IEEE802.3 4P Task Force

Updating 33.3.7.10 per D1.5 requirements
January 2016

Yair Darshan/Microsemi
yadarshan@microsemi.com

33.3.7.10 PD PI pair-to-pair resistance and current unbalance

Figure 33-18a – PD PI pair-to-pair test circuit

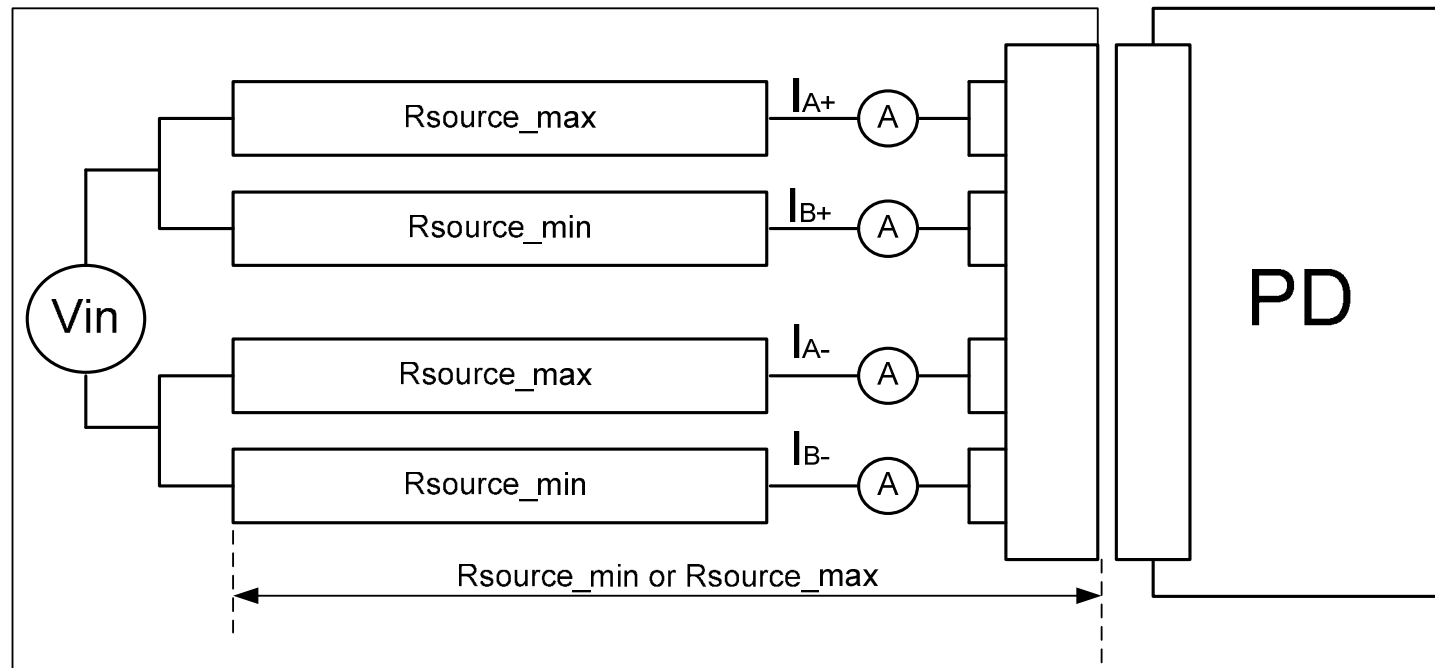
- a) The drawing of the test circuit was modified to show clear boundaries of Rsource min/max
 - b) The effect of the test circuit connector resistance on Rsource is minimized by specifying max connector resistance (plug of the test circuit, it is practical to use in test circuit side high quality connector) and subtracting it from Rsource. In addition we increase the Rsource ABS numbers by 5% and allow 5% variations with negligible effect on current measurements. The PD RJ45 Jack is not part of the test circuit.

2. Update Figure 33-18a below:

1. Rsource includes test setup plug resistance Rcon. The maximum recommended Rcon value is 0.02 Ω however it is test setup implementation specific choice how to meet Rsource_min and Rsource_max.
2. The test needs to be conducted when in one test the two pairs of the same polarity contain Rsource_min and Rsource_max and in the 2nd test it flips values.
